TG13.1 – Roof Park Landscaping and Irrigation

Questions are numbered in the order received. Numbers missing in the sequence either have been answered in a previous response set or will be answered in a future set.

-9681

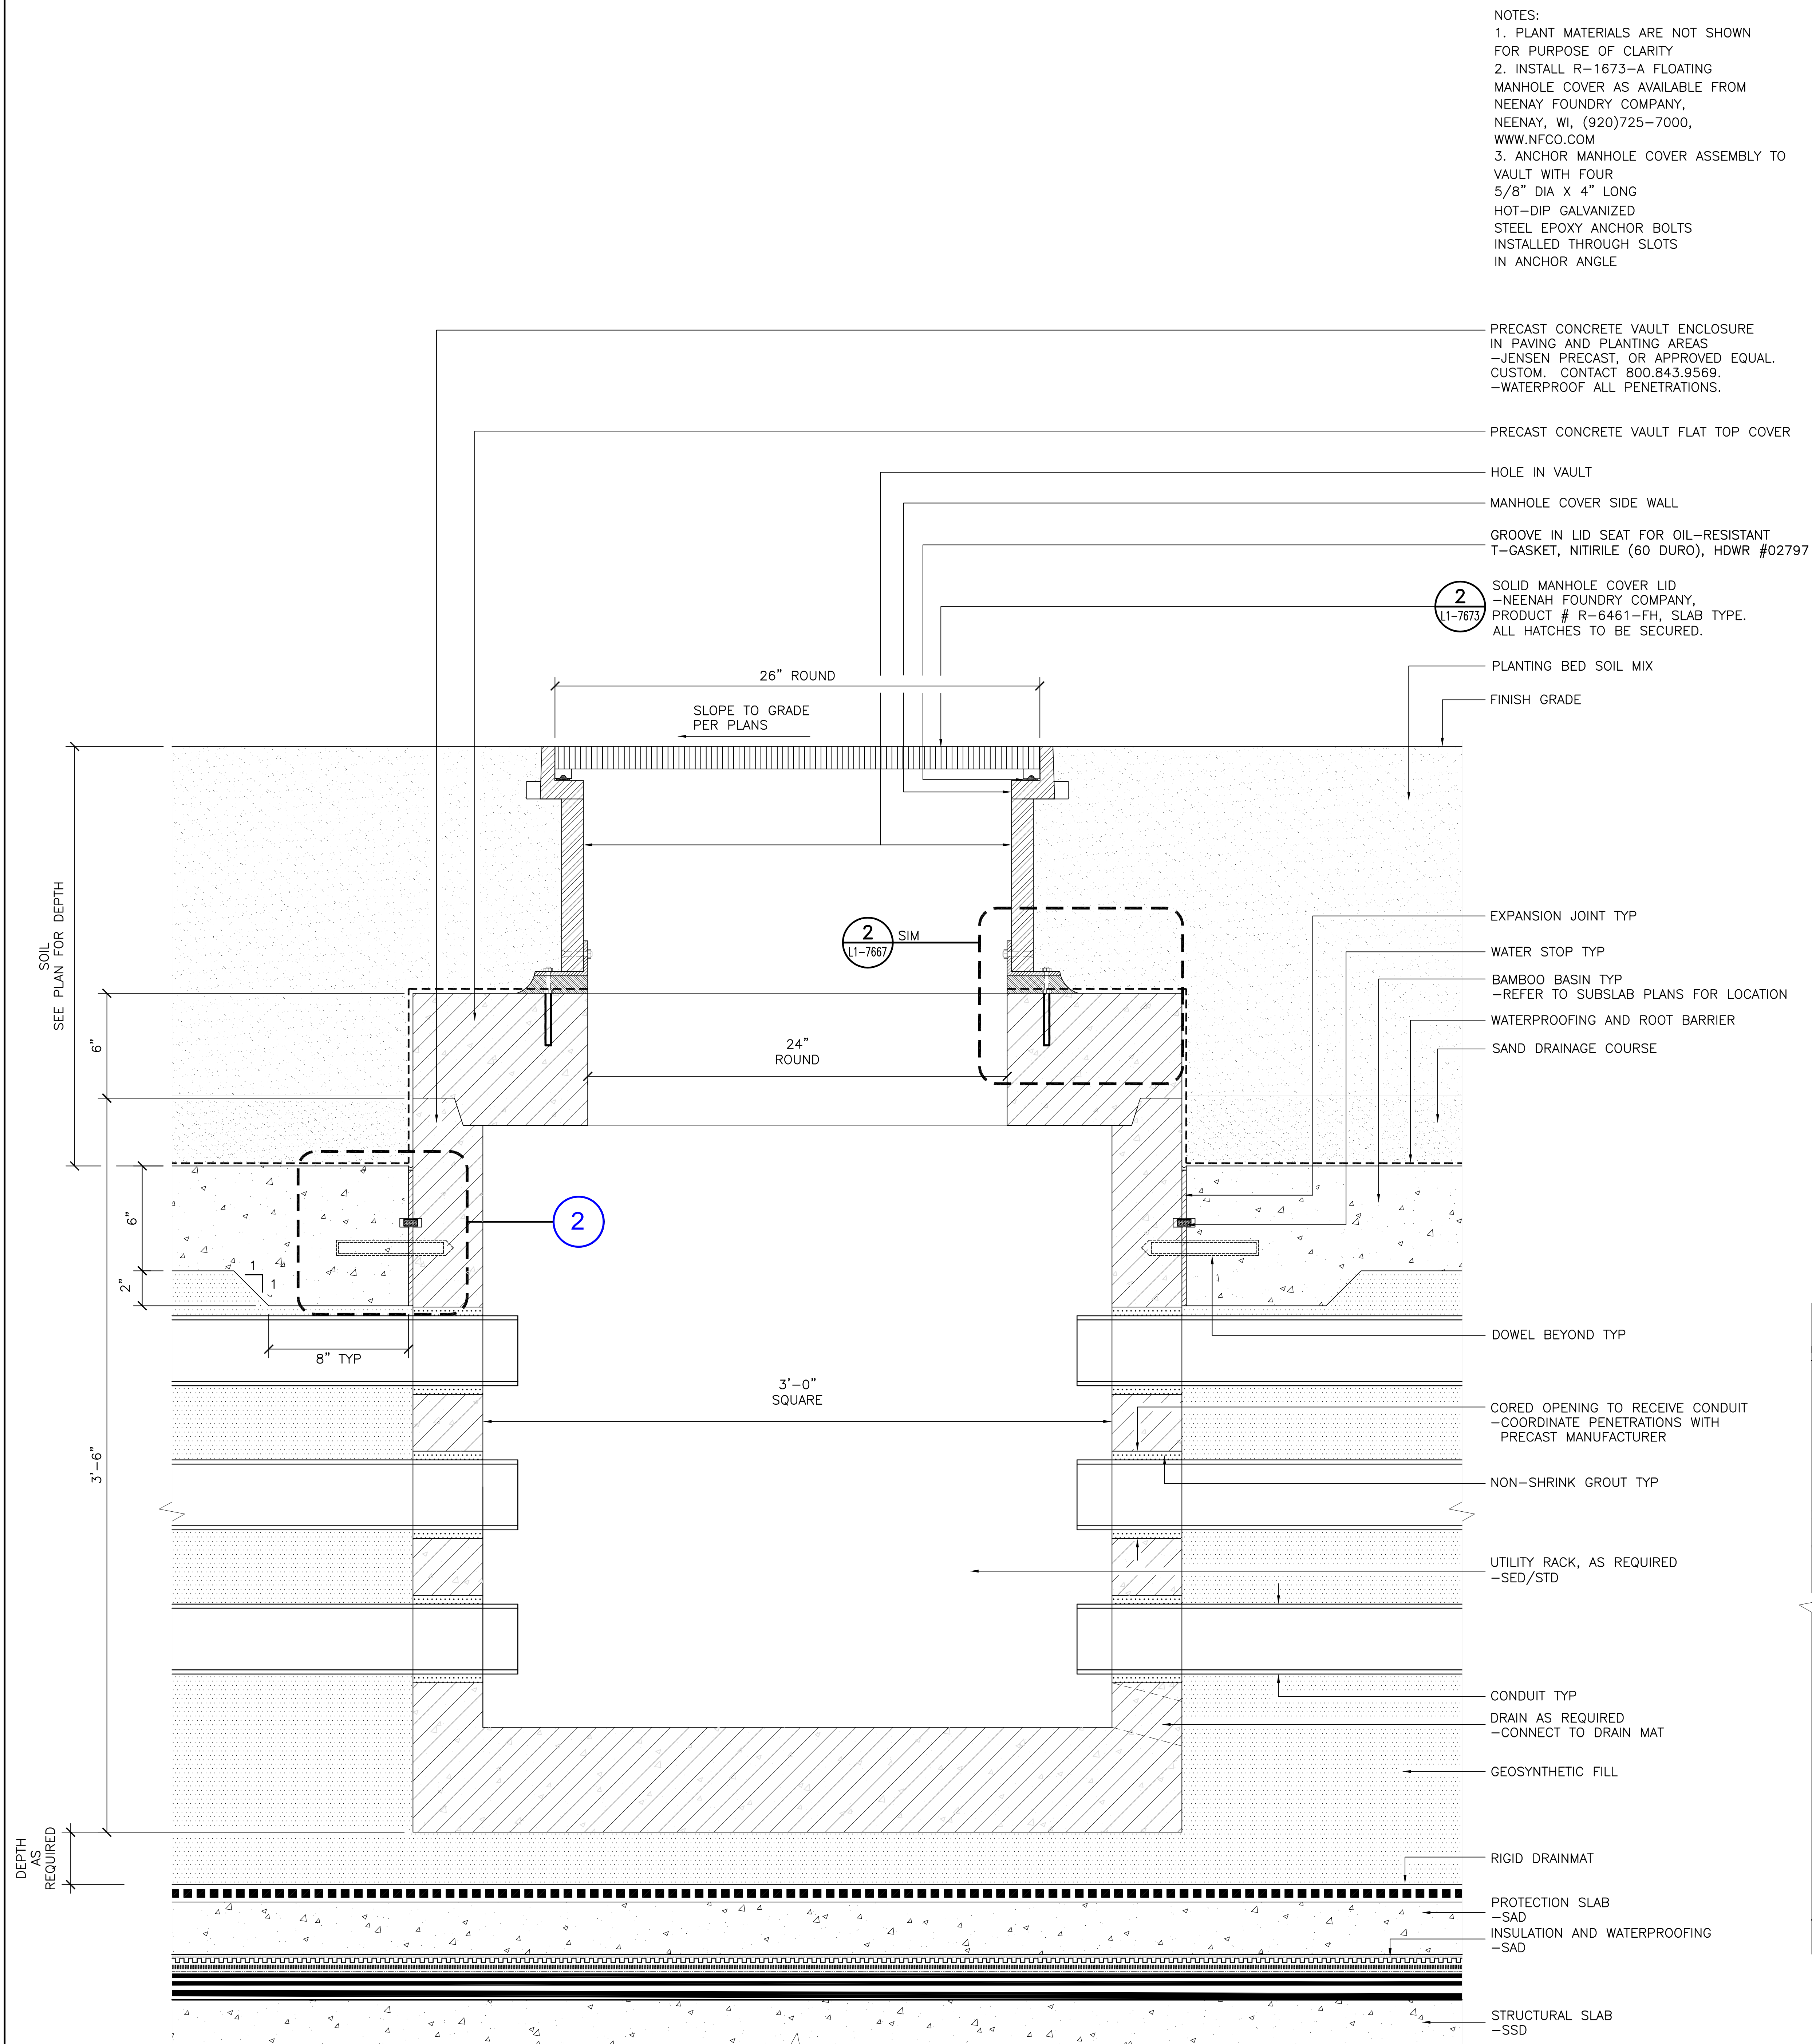
TG13.1-023	3/25/2015	L1-6623, L1-6626, L1-9680, L1-9681		Define the type of plant required on the East and West Mounds. L1-9680 shows ta on the detail, but there is no ta in the Shrubs and Perennials Schedule. L1-9681 only shows black dots.	The planting required on the east and west mounds is Trachelospermum Asiaticum, identified as "GC-TA" on sheets L1-6623 and L1-6626, and identified on the planting legend sheet L-0009. Please refer to SKLA 385.1, 385.2, 385.3 and 385.4.
TG13.1-024	3/25/2015	L1-1605, L1-1606		Provide details for Utility Vaults within the Bamboo Grove Basins.	Please refer to attached SKLA 387 for the utility vault within the bamboo basins.
TG13.1-025	3/25/2015	L1-4606		The Stair 601 area drain in paving at GL 30.3 / F shows an invert elevation of 84.09 which is higher than the drain lines flowing to it. Confirm if this is in fact the correct elevation. If this is incorrect, provide the correct elevation and update the detail.	The invert elevation at the stair 601 area drain was omitted as shown on attached SKLA 384-1. Please refer to architectural and plumbing details for the drainage.

APPROVED:
PRINCIPAL ENGINEER / ARCHITECT **D. ANGHEL**
APPROVED:
PROJECT MANAGER **W. GAW**
APPROVED:
PROJECT MANAGER **W. GAW**
DESIGNED BY:
M. ANGHEL
CHECKED BY:
G. CRAIG
DATE:
12/16/2014
SCALE:
1/8" = 1'-0"
SHEET NUMBER
RFI TG13.1-026
SEQUENCE NUMBER
SKP1-2506 of **0**

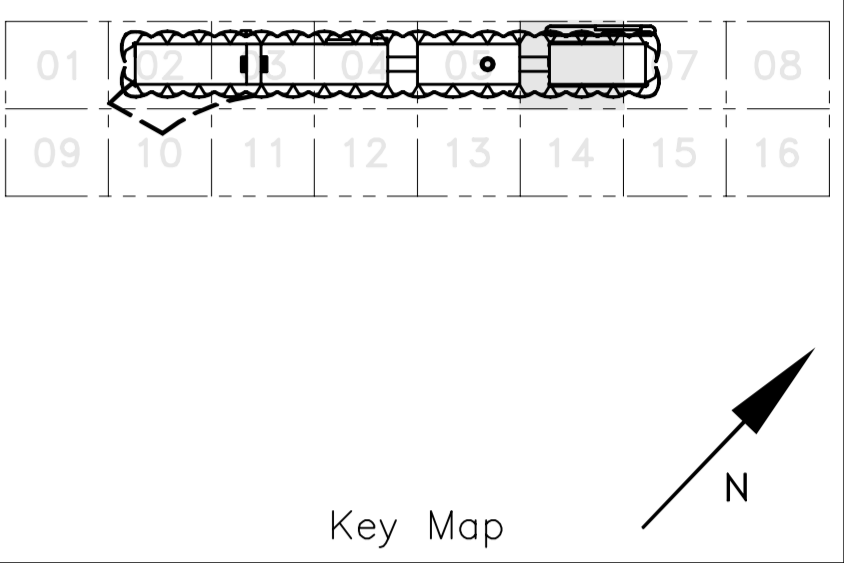
TG13.1-026	3/25/2015	L1-4606		Clarify where the Stair 601 area drain at GL 30.3 / F drains go to. It does not appear to drain to a roof drain. Where is the plumbing connection?	Provide an area drain at the main roof slab level below Stair 601 landing. Provide drain piping for the area drain at landing and other drain lines connected to the area drain piping shown on drawing L1-4606. Please refer to attached sketches SKP1-SKP1-2506, SKP1-2606 and SKA-4578.

1 PARK LEVEL ZONE 05 TREE PLANTING PLAN
 L1-6605 SCALE: 1/8" = 1'-0"

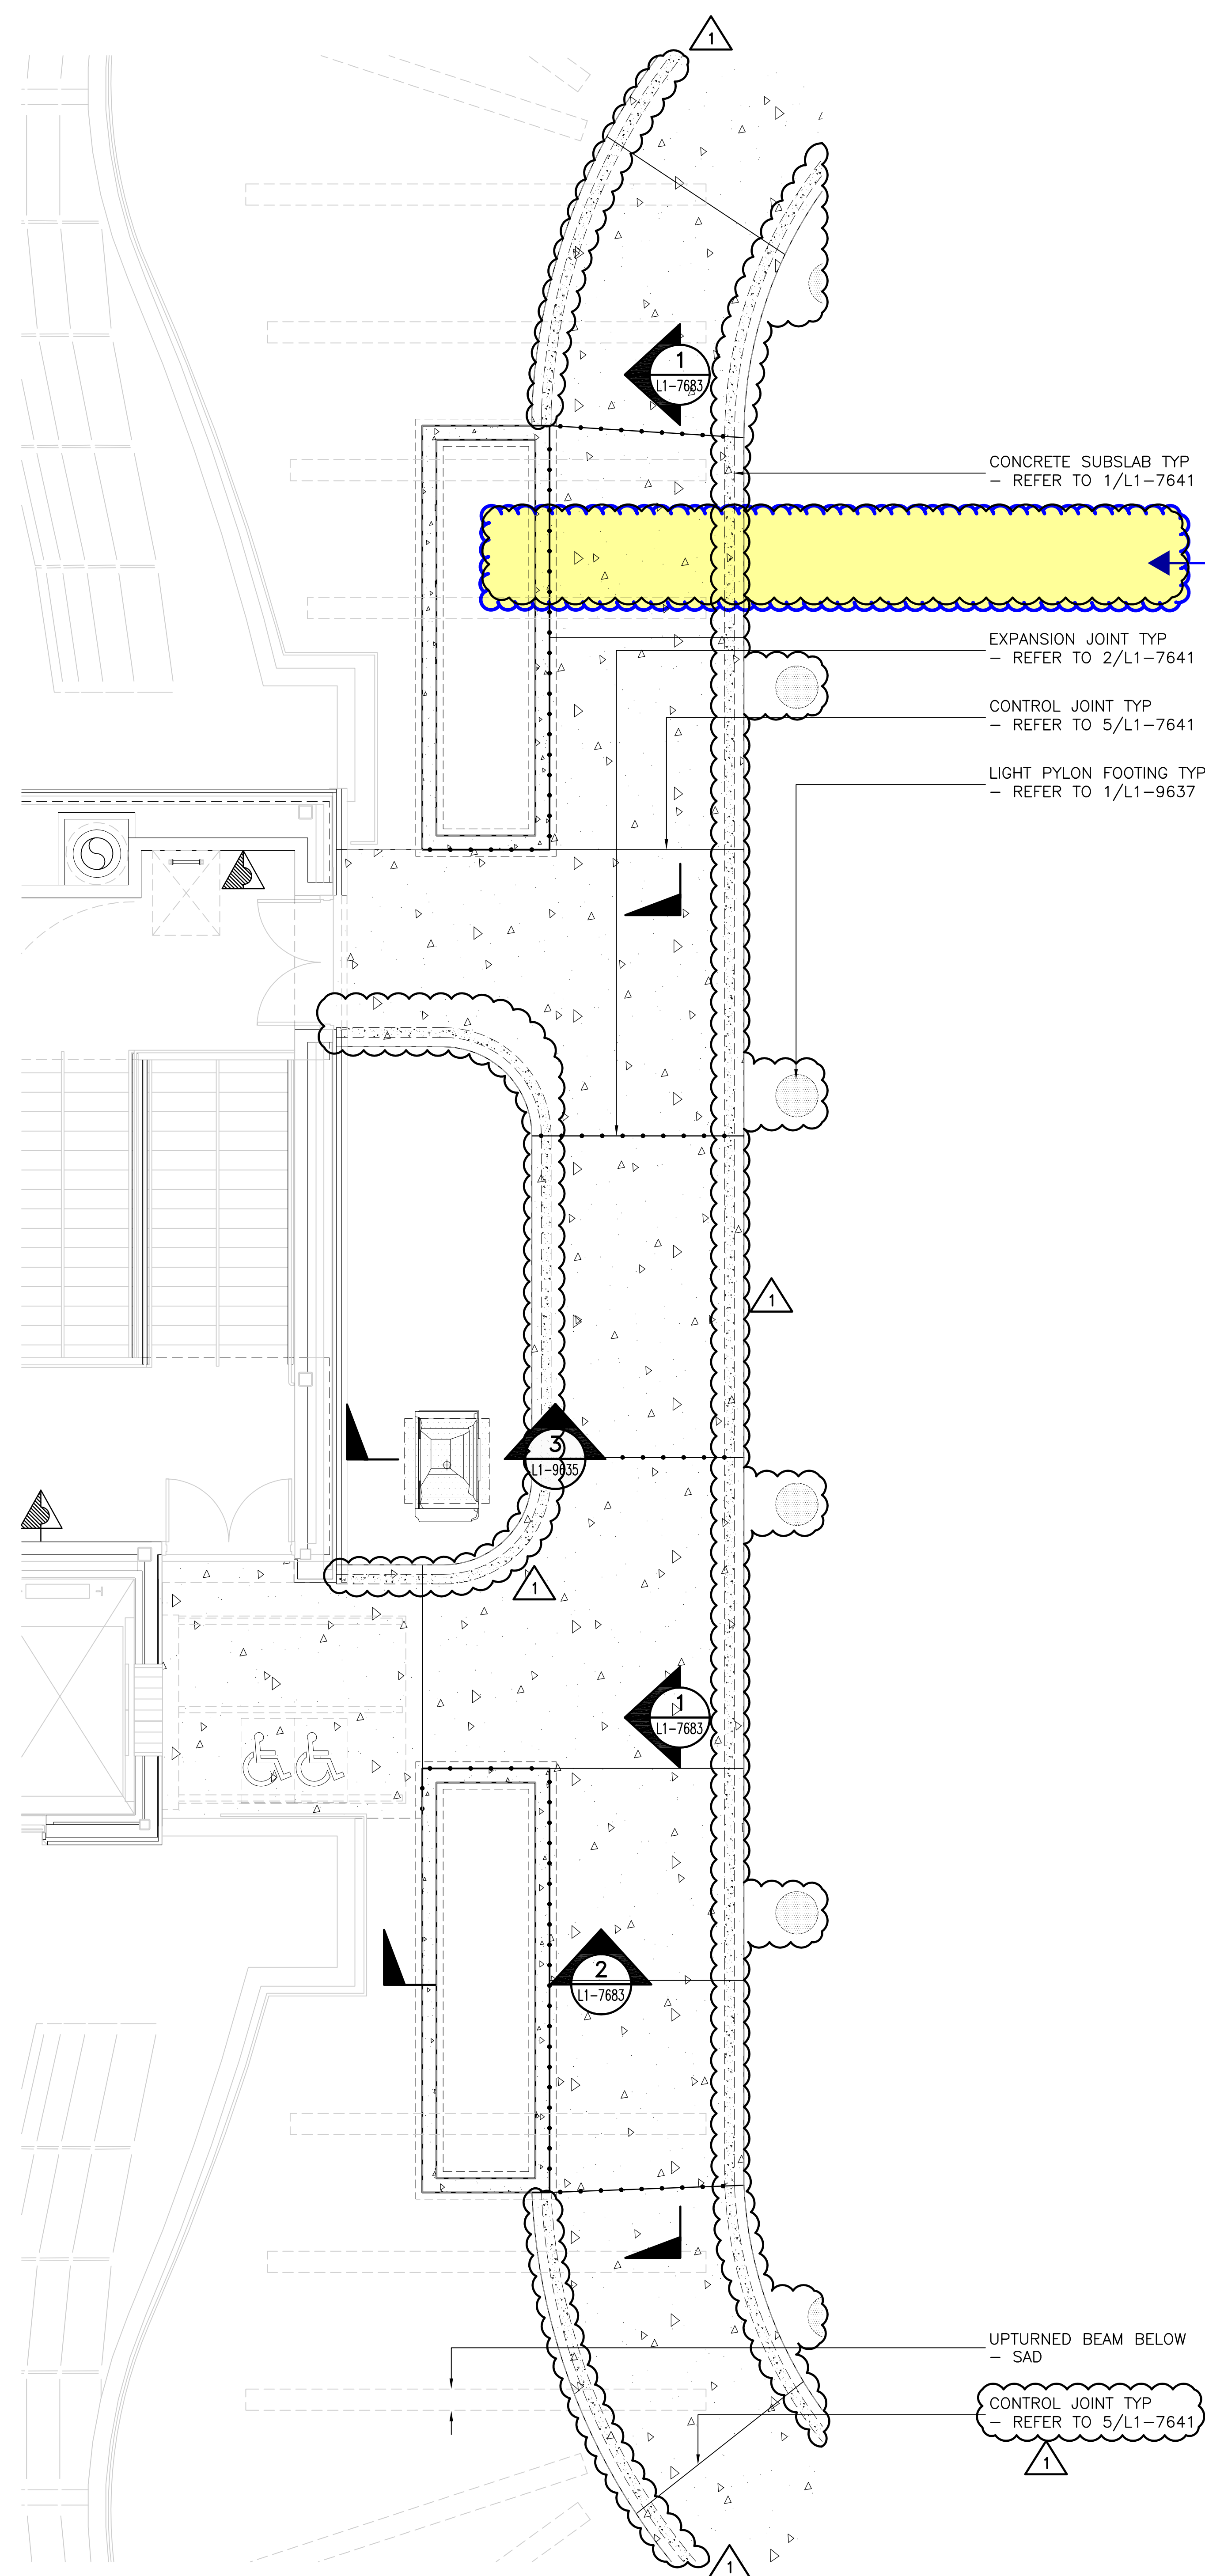
TG13.1-032	3/27/2015	L1-6603 thru L1-6607		Sheet L1-6603 thru L1-6607 show vine planting at the Green Screen locations but they do not provide a species and/or plant size. Please clarify.	Refer to sheet L0006 for species and size.
TG13.1-033	3/27/2015	L-0006 - L-0007		On sheet L-0006 and L0007 - Tree Planting Schedule - Please clarify if the following tree sizes are to be per the 'container' size call out or the Abbreviated callout. AC60 - Aesculus Californica and/or container size 48" box tree. QT60 - Quercus Tomentella and/or container size 36" box tree. LA36 - Leucadendron Argenteum and/or container size 24" box tree.	As indicated in the construction documents: AC60=48" box OT60=36" box LA36=24" box
TG13.1-034	3/27/2015	L1-6605		Per sheet L1-6605, there is a tree called out 'HF48', but there is no HF48 tree called out on the tree planting legend on sheets L-0006 and L-0007. Please clarify this tree type and size.	'HF 48' should be 'HM48'. Please refer to the attached SKLA 390.1 for the tree type clarification.
